Sundry ID: 2856744

Procedure Description: WPX Energy Permian, LLC (aka Devon Energy Production Co, LP) respectfully requests a drill plan change for the subject wells. WPX also requests break test and offline cementing variances. Please see revised drill plan for the deepest TVD well on this pad and variance attachments.

**PECOS DISTRICT
DRILLING CONDITIONS OF APPROVAL**

WELL NAME & NO.:	Steel Guitar 35-26 Fed Com 324H
ATS/API ID:	3001555935
APD ID:	10400095587
Sundry ID:	2856744

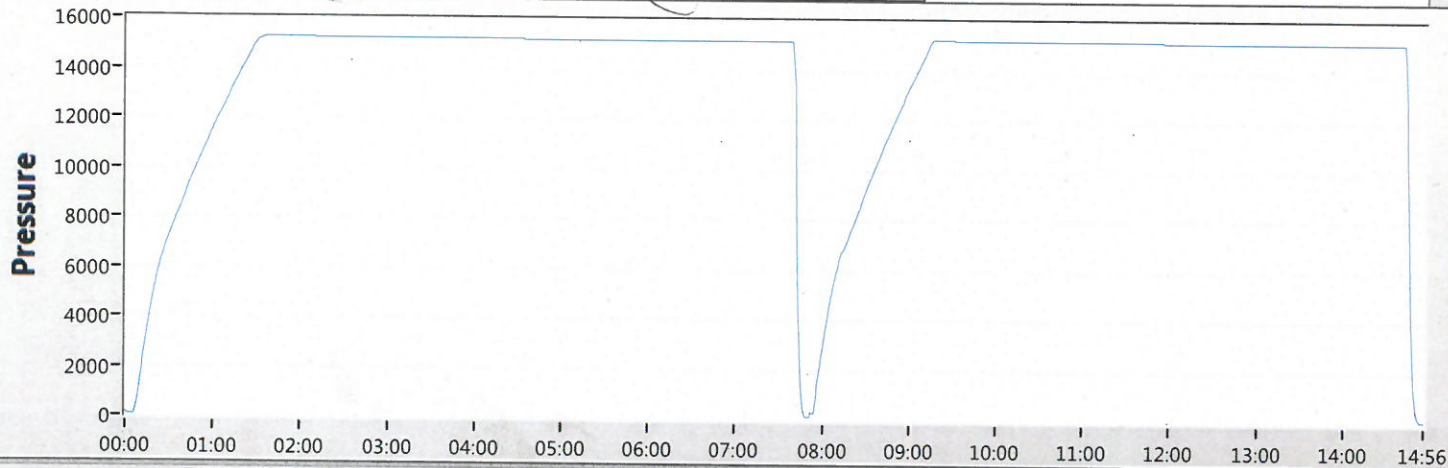
Devon requests offline BOPE testing for the following components: Upper Rams, Blind Rams, Kill Valves, Choke Valves, and Annular

Devon requests Break testing as stated above for 5K tests, not including production hole

Annular Preventer will be tested to minimum of 70% RWP and higher than MASP during initial BOP test

Pressure testing is required for pressure-containing connections if the integrity of a pressure seal is broken during a break test

Full Tests required when entering production hole

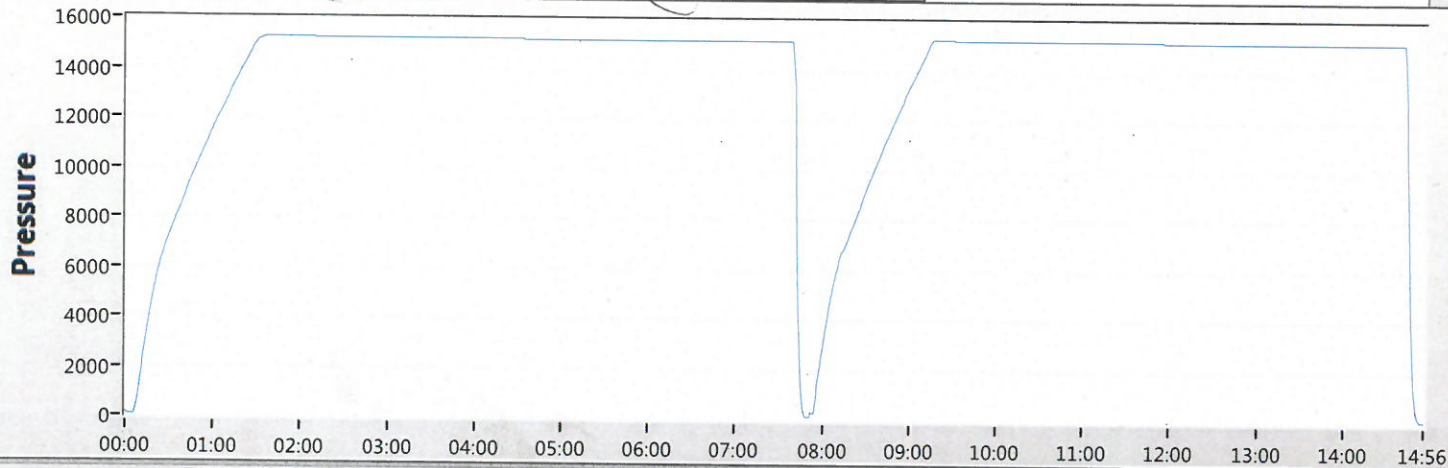
Annular Preventer will be tested to minimum of 70% RWP and higher than MASP during initial BOP test

Pressure testing is required for pressure-containing connections if the integrity of a pressure seal is broken during a break test

Full Tests required when entering production hole
